**ELECTRONIC AGENDA PACKET FOR
THE PUBLIC HEARING OF
MONDAY, MARCH 7, 2022
8:00 P.M.***

1. [Petition 2020-08-01-06 submitted by Middlebelt Plymouth Venture L.L.C. pursuant to Section 13.15 of the Livonia Vision 21 Zoning Ordinance, requesting to rezone parts of the properties at 29707 & 30273 Plymouth Road, located on the south side of Plymouth Road between Middlebelt Road and Milburn Avenue in the Northeast ¼ of Section 35, from C-2 \(General Business\) to NM2 \(Neighborhood Multifamily\).](#)

Petition 2020-08-01-06 submitted by Middlebelt Plymouth Venture L.L.C. pursuant to Section 13.15 of the Livonia Vision 21 Zoning Ordinance, requesting to rezone parts of the properties at 29707 & 30273 Plymouth Road, located on the south side of Plymouth Road between Middlebelt Road and Milburn Avenue in the Northeast ¼ of Section 35, from C-2 (General Business) to NM2 (Neighborhood Multifamily).

**RE: Petition #2020-08-01-06
Rezoning Re-Submission Planning Commission Agenda
Wonderland Village – Plymouth and Middlebelt**

REVISED LINE OF SIGHT SECTION

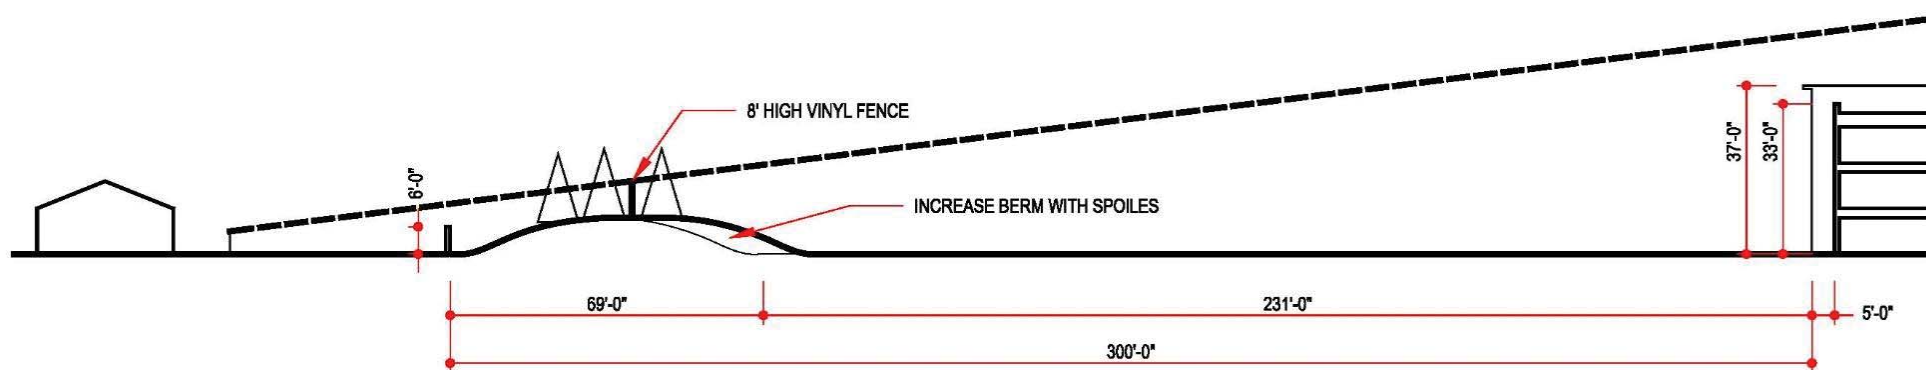
- **Slide 5: Market Study and Proposed Amenities**
- **Slide 8: Use Exhibit** – Existing Zoning vs Proposed Zoning
- **Slide 9: Site layout** – Previous Proposal vs Current Proposal
- **Slide 10: Rendered Site Plan** – Showing enhanced landscaping and fence screening along south
- **Slide 11: Building Perspective** – Showing enhanced landscaping along existing drive lane
- **Slide 13: View from Backyard of Single Family** – Showing the previous submission vs revised with enhanced landscape and screening.
- **Slide 14: Line of Sight Section** – Showing previous line of sight vs proposed with enhanced landscape and screening.
- **Slide 15: View from Third Floor of Apartments** – Previous view from 3rd floor vs proposed view with enhanced landscape and screening.

PRELIMINARY SITE PLAN

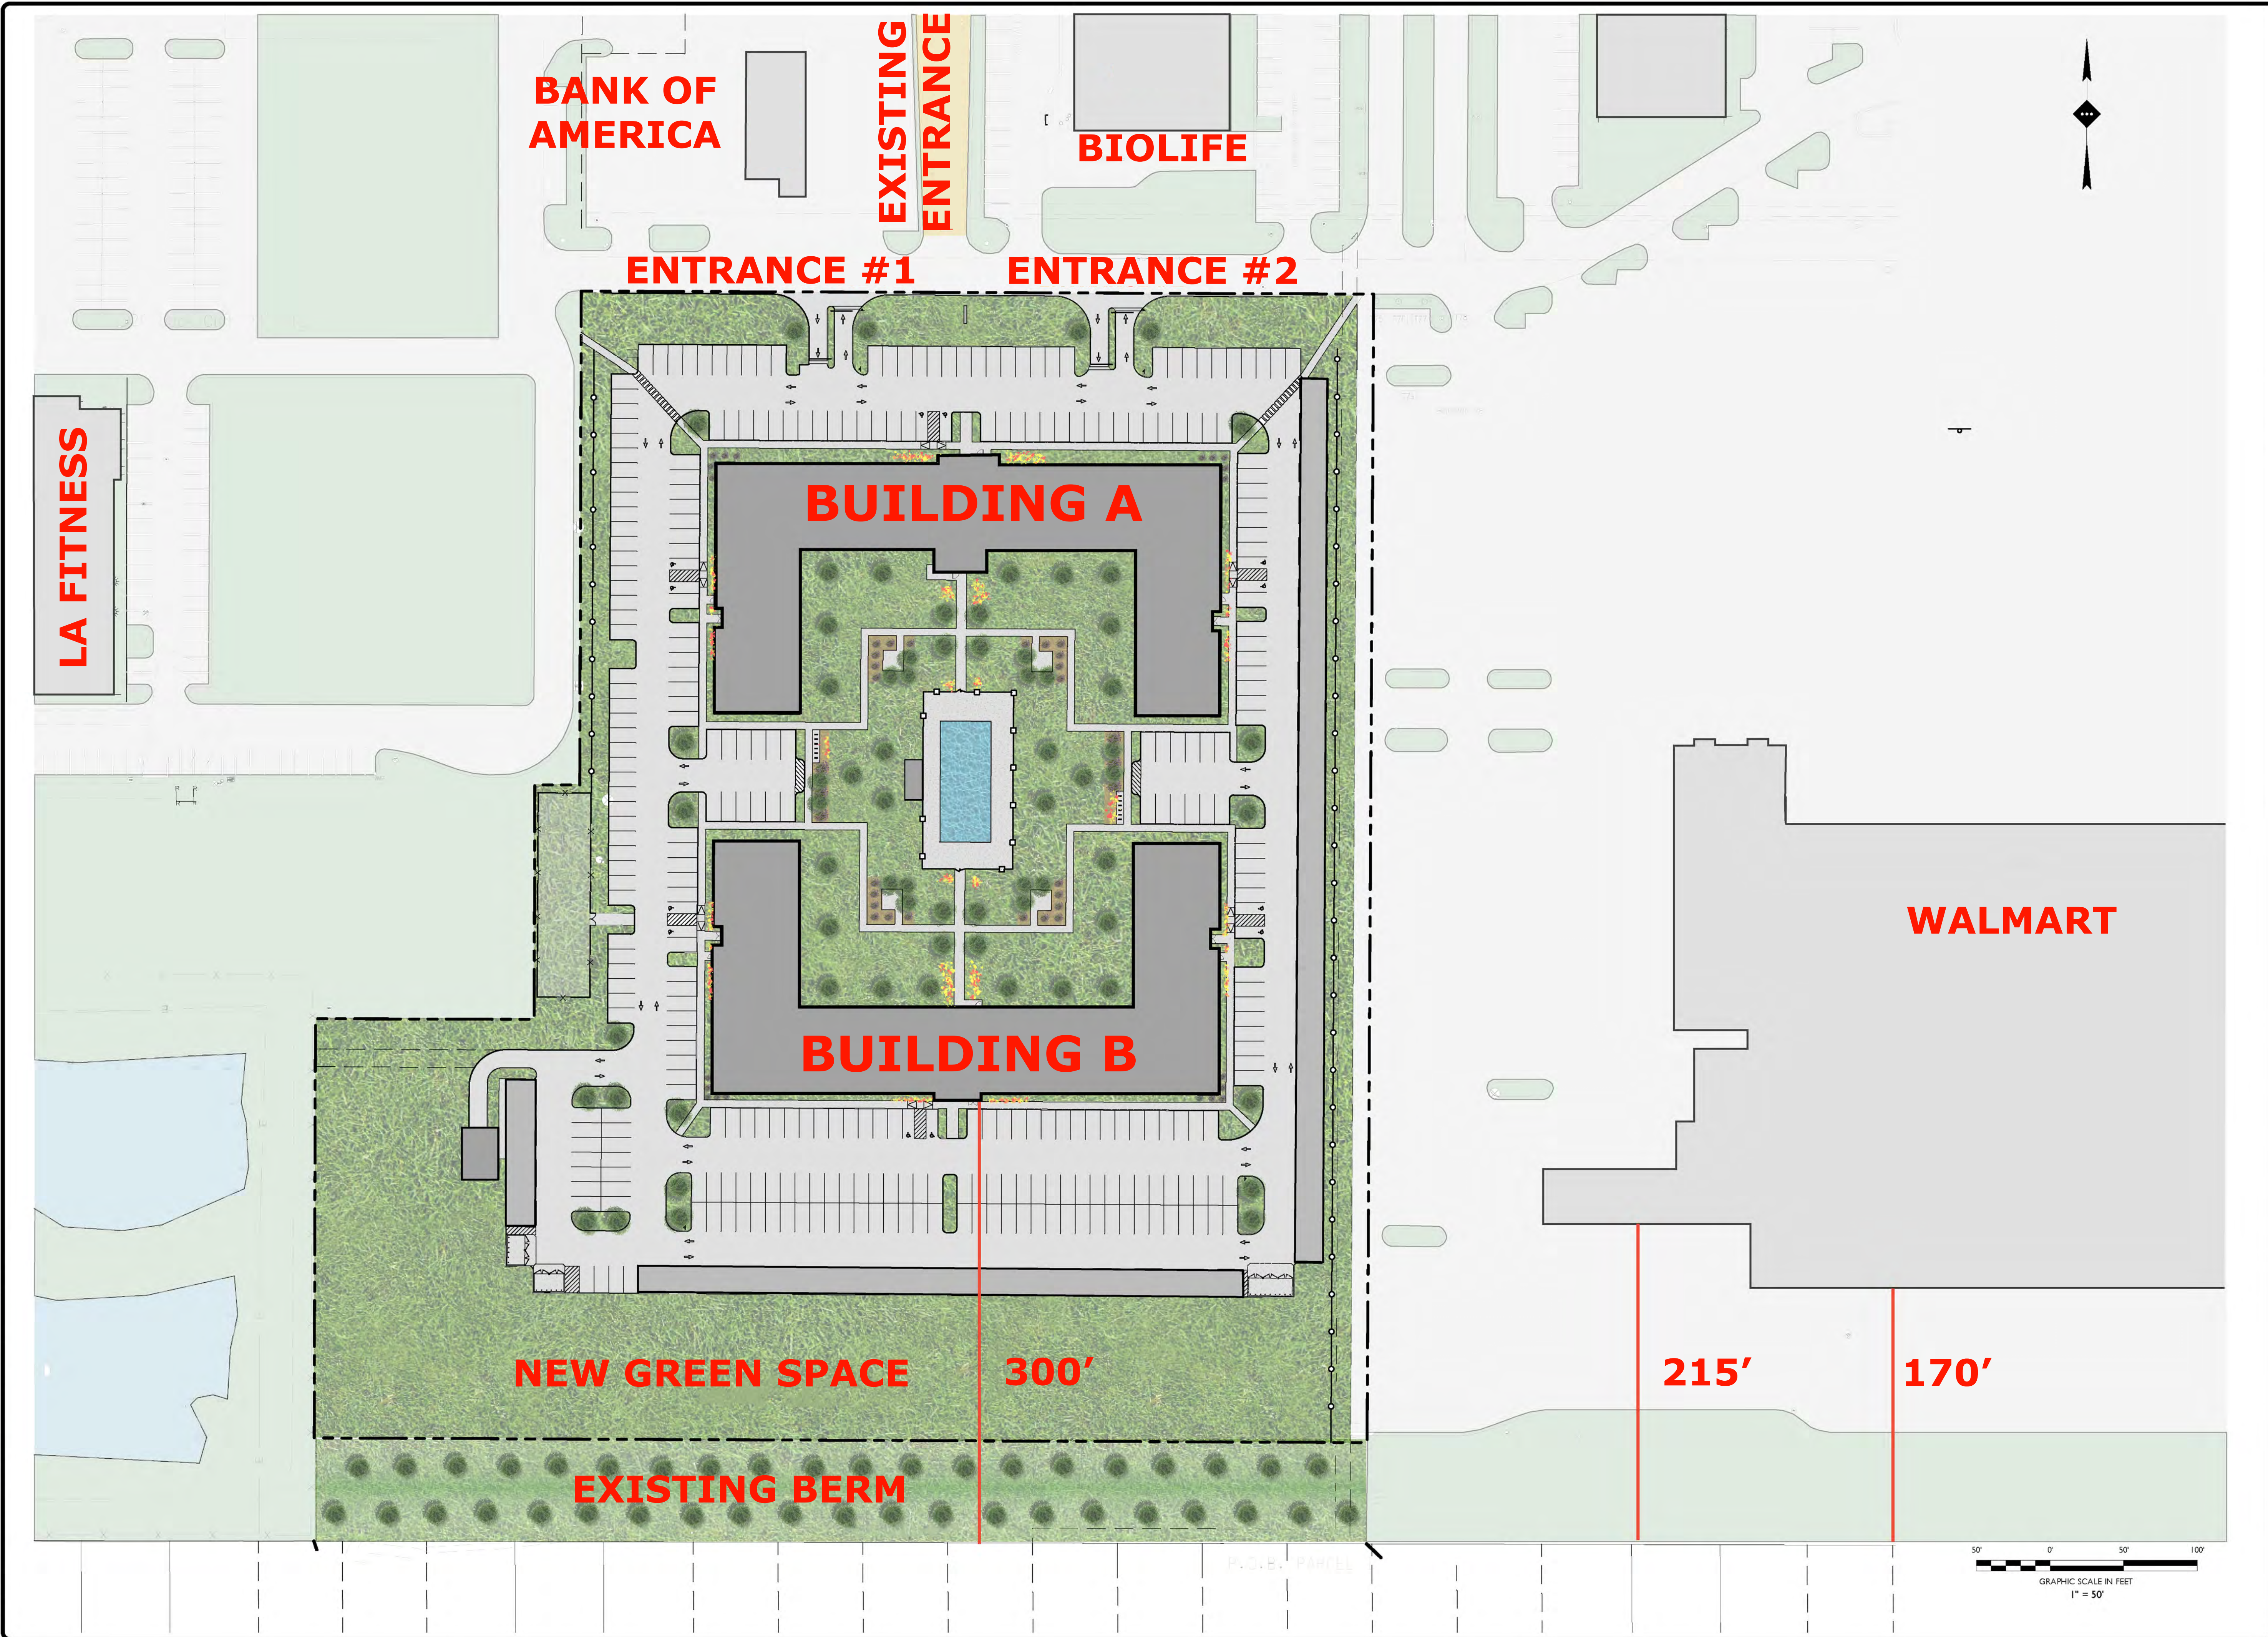
SITE PLANS C-3 (black & white) & C-4 (colored up), C-5 (colored up overviewed)

On C-3, to supplement this email, we provide further detail on legend: (1) "TABLE OF LAND USE AND ZONING" and (2) "OFF STREET PARKING REQUIREMENT", to further describe the "required" vs "proposed"

Most of the changes to the site plans (C-3, 4, 5) were the result of the NM2 ordinance, now incorporated into the plans as follows:
